**Stanislaus County Final ISMND Package
Response to Comments Memo**

Subject: **Response to Comments**
Public Draft Initial Study/Mitigated Negative Declaration (IS/MND)
Well Permit Application Nos. 2021-69, 2021-70, 2021-71, 2021-72 and Two
Future Permits
Hunter Ranch, Stanislaus County, California

Figure 8
Predicted Drawdown Extent Comparison

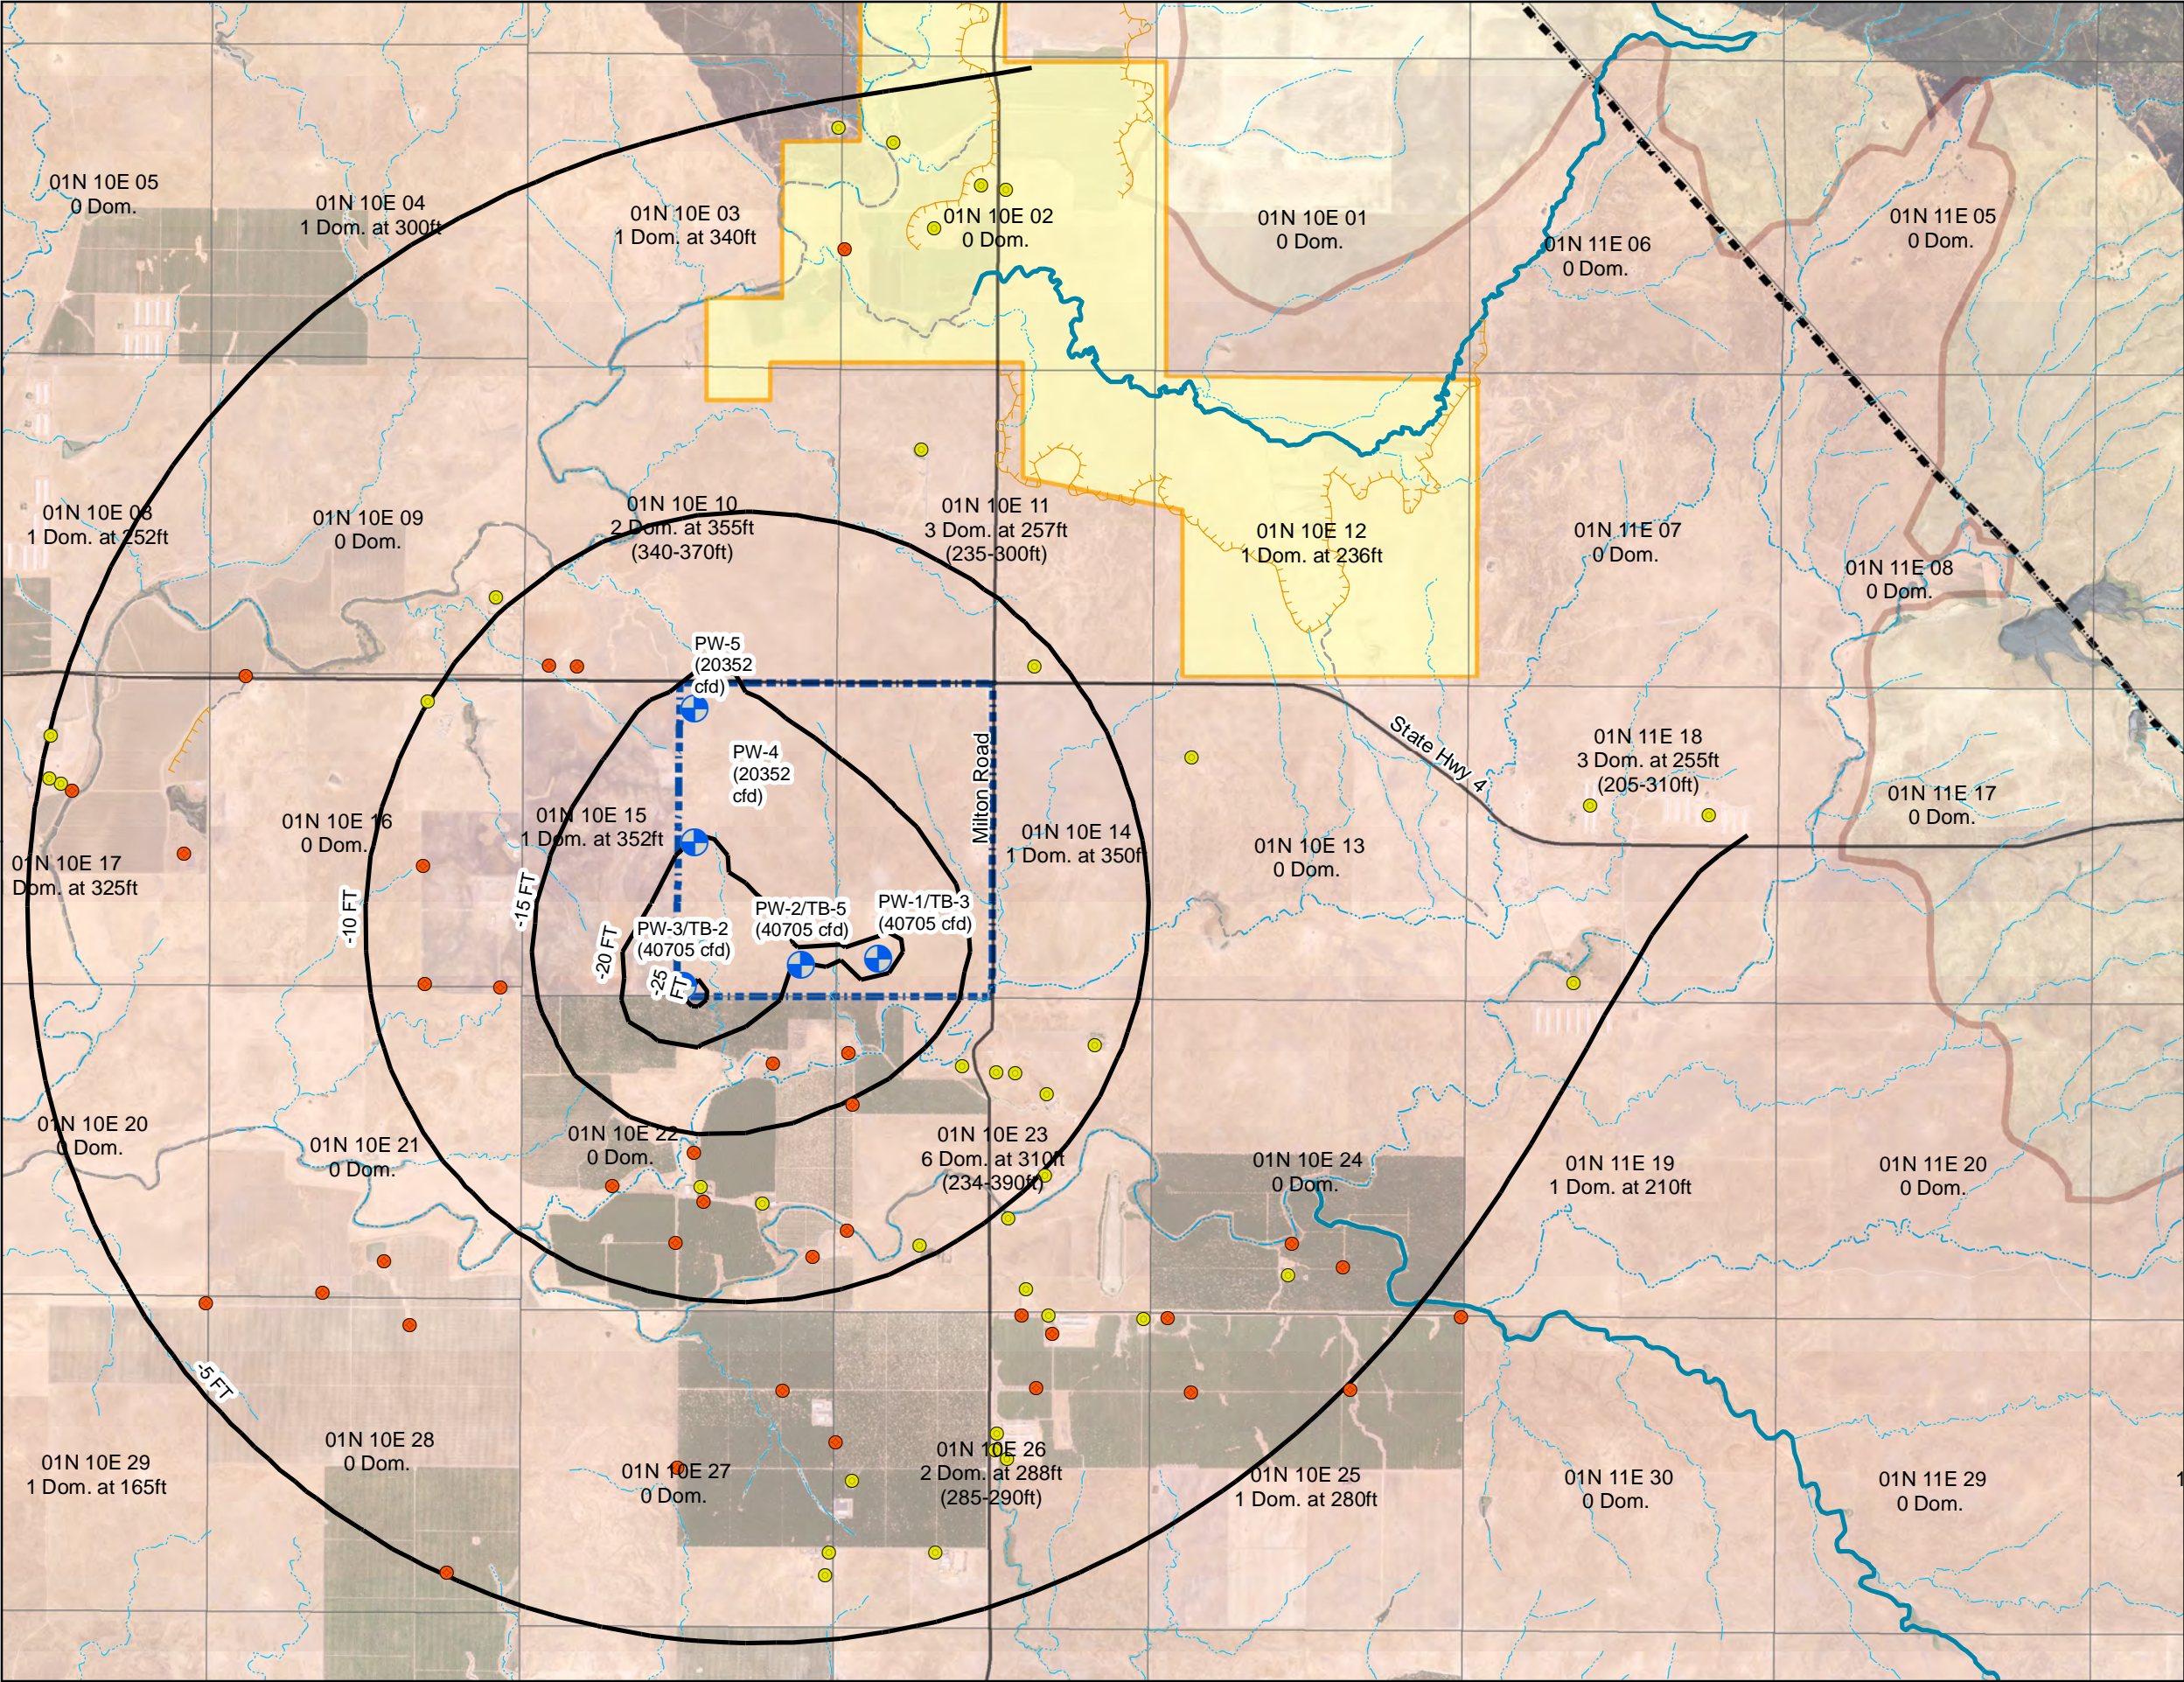
Figure 8 illustrates the extent of drawdown predicted in Layer 3 (the Valley Springs Formation aquifer) is somewhat greater than in Layer 1 (the Mehrten Formation aquifer), especially in the northeast direction toward the presumed no-flow boundary at the edge of the basin. This is consistent with Layer 3 being more strongly confined than Layer 1, which results in a broader cone of depression. Review of well completion records for 2 miles in each direction from the Site indicates that most irrigation and domestic wells are completed in the Mehrten Formation. Based on the analysis presented in Section 4.4, wells that are completed in both formations would derive most of their water from the Mehrten Formation. For these reasons, the discussions below focus on predicted drawdowns in Layer 1 (the Mehrten Formation).
